DATE: February 19, 2015

TO: Planning Commission

FROM: Neighborhood Planning Committee

SUBJECT: *West Side Flats Master Plan and Development Guidelines* – Summary of Public Testimony and Committee Recommendations

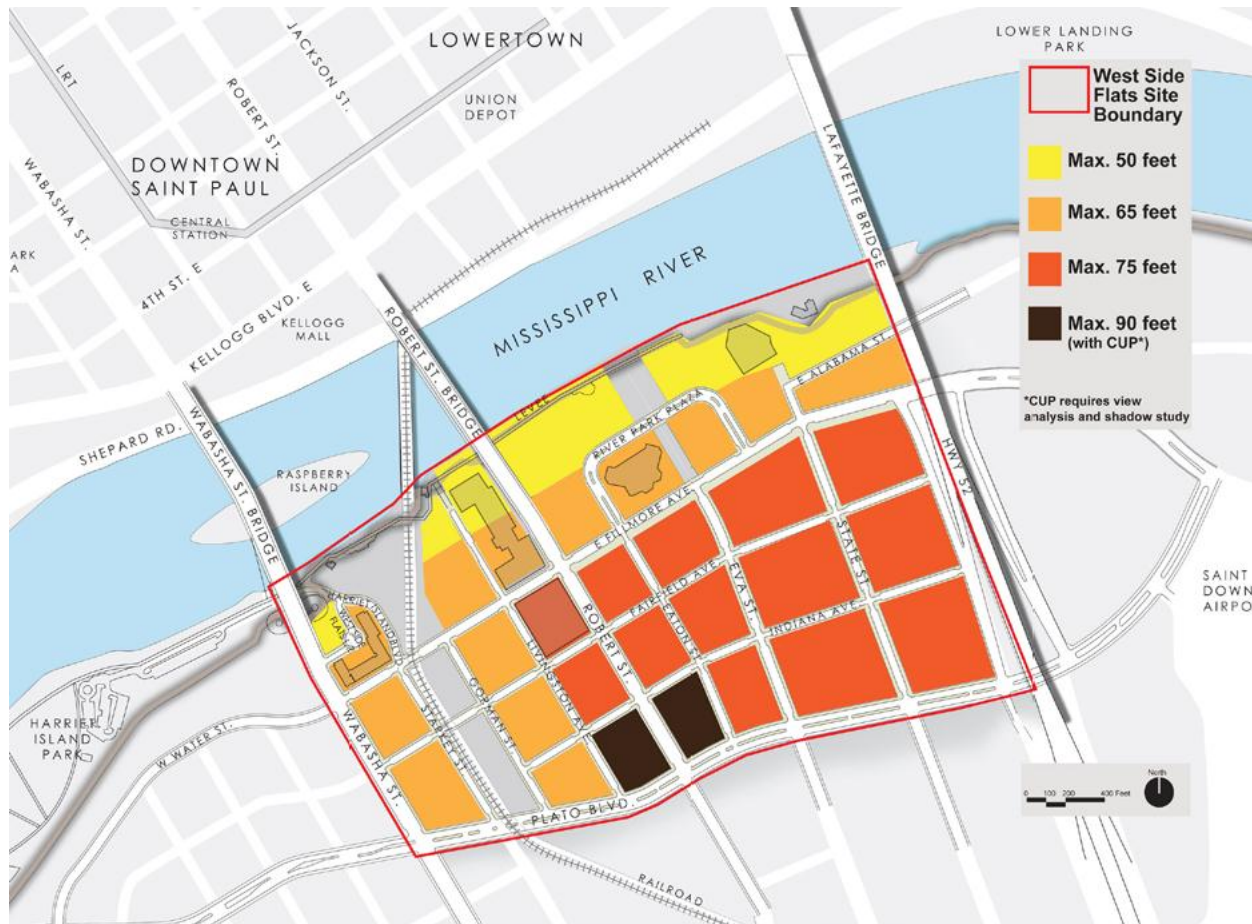
Most of the opposition to the draft Master Plan was presented by current or past employees of Rexam. They stated strong concern that the Rexam building is not shown on the Illustrative Plan on pg. 64, and that it is replaced with Eva Street Park and three new streets. Although the draft Master Plan states that the construction of new streets and parks throughout the planning area would be likely only in conjunction with private redevelopment; that parcels can be put to any legal use permitted under current zoning until such time as the City has the resources to build the recommended streets and parks; and that infrastructure changes in the area east of Robert and south of Fillmore are likely to occur in Phase IV (of IV, 20-30 years out), Rexam employees feel the future of their company is threatened. Most of the Rexam speakers asked that the Phase IV improvements be deleted from the Master Plan.

1. Remove the proposed streets and park east of Robert Street between Fillmore Avenue and Plato Boulevard from the Master Plan base map, which would remove them from all of the individual master plans (land use, urban design, acceptable building heights, street system, transit system, pedestrian and bike circulation, parks and open spaces, green infrastructure and public art) as well as the Illustrative Plan. The Illustrative Plan would show existing buildings and streets east of Robert between Fillmore and Plato, with a “bubble” explaining future strategies to pursue as redevelopment occurs in this area. As an example, a revised Street System Plan and Illustrative Plan are attached showing how the maps would look with these changes.

2. **Option B:** Remove the proposed street and park improvements for Phase IV from all base maps and the Illustrative Plan; remove the time frames noted after each phase (pg. 107-108); replace the language under Implementation Phase IV with the following bullets and add this guidance to the Illustrative Plan:
